NR/NA Containment Improvement

Concept of Upgrade Solution

Solution concept

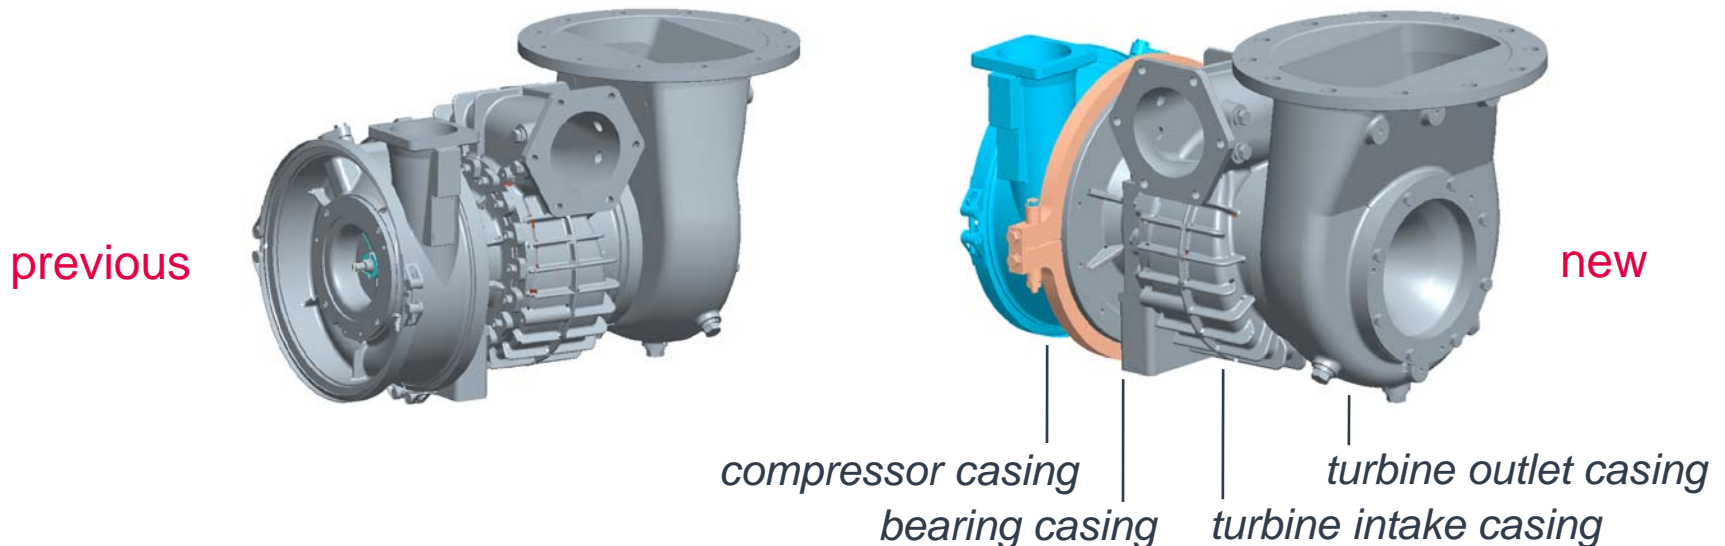
With NR and NA turbochargers, the casings and/or the flange connections are not sufficiently strong to withstand extreme load situations which may for example occur in the very rare case of a rotor failure.

- Modification of the casing design (compressor casing, insert piece)
- Modification of connection of compressor and bearing casing
- Scope (number of components) varies per turbocharger type

- The upgrade kit comprises all required parts to perform the upgrade (including sealing rings etc)
- In some cases the turbocharger has to be lifted from the engine to install the kit
- In some cases a rib of the foot holding the turbocharger must be grinded
- Assembly time depends on scope (4 - 24 h)
